US ALUMINUM 950 SOLON RD. WAXAHACHIE, TX 75165		
SERIES 800 DOUBLE DOOR NON-IMPACT NOTES		
DRAWN: A.P.	DWG NO. 08-01837	REV B
SCALE NTS	DATE 10/22/12	SHEET 1 OF 5
L. ROBERTO LOMAS P.E. 400 S. PALM AVE, INDIALANTIC, FL 32903 434-688-0609 rllomas@rlomaspe.com

SERIES 800 DOUBLE DOOR
NON-IMPACT
ELEVATION

SERIES 800 ALUMINUM DOUBLE DOOR
EXTERIOR VIEW

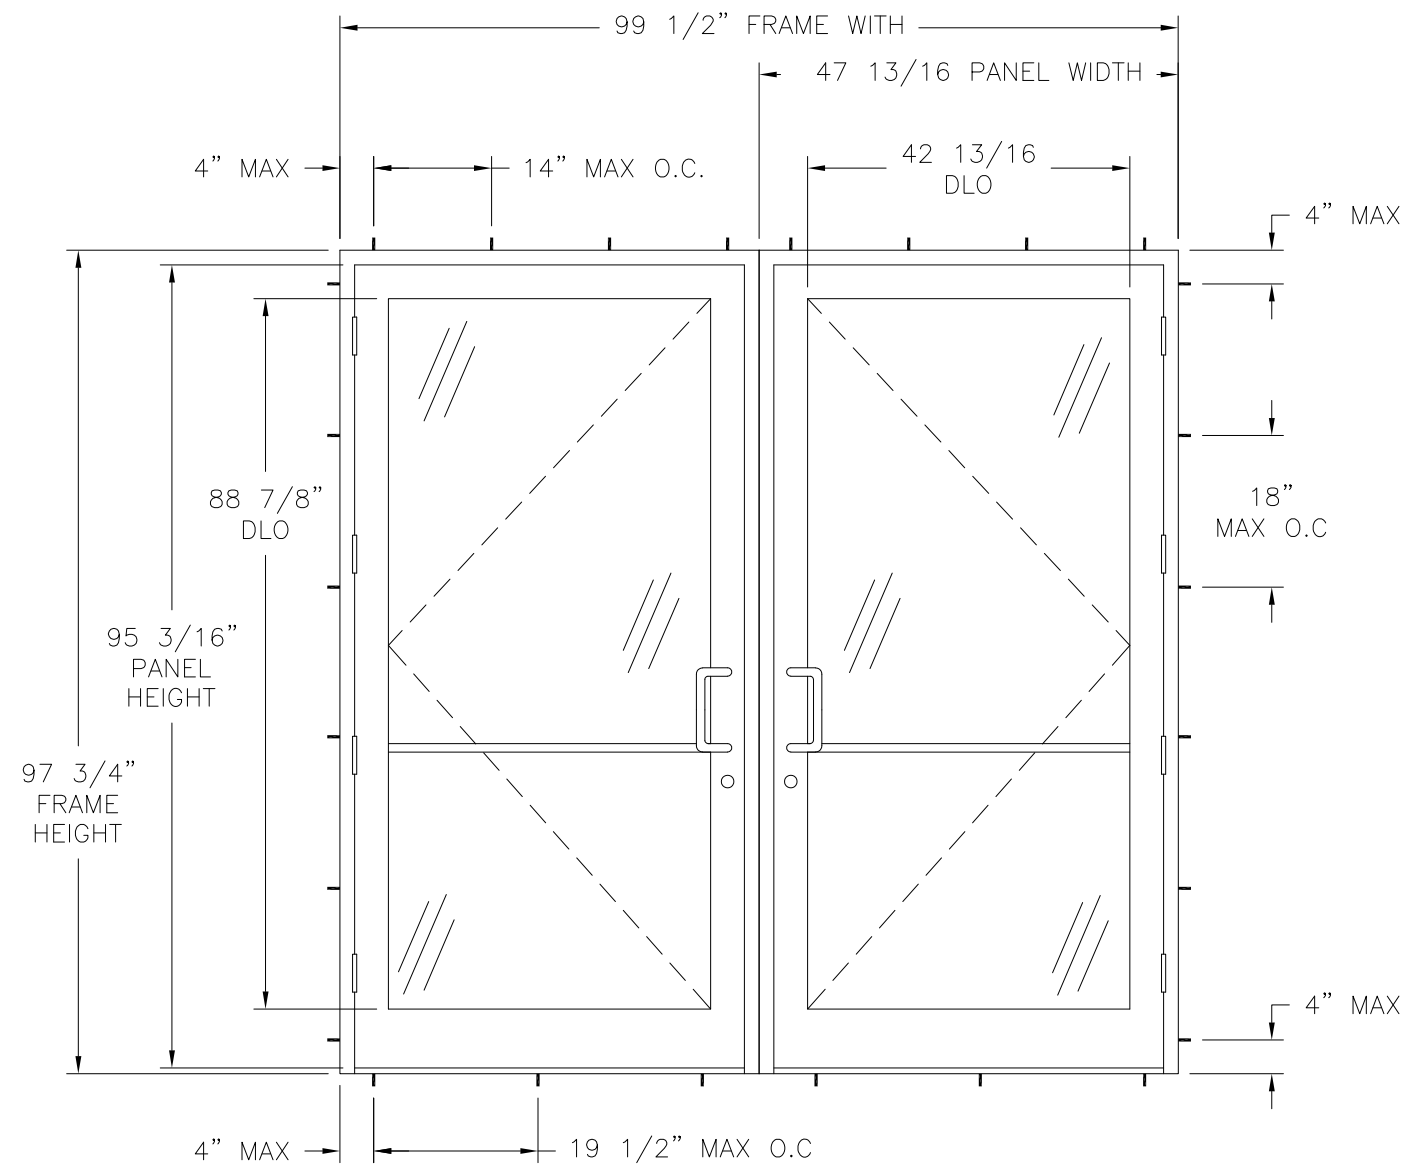
THE CALCULATIONS WEREN'T MADE. I TRIED TO DO THE COMPARATIVE ANALYSIS BUT THE DESIGN PRESSURES ARE DIFFERENT FROM THE CHART. I BASED THE ANALYSIS IN 512522A
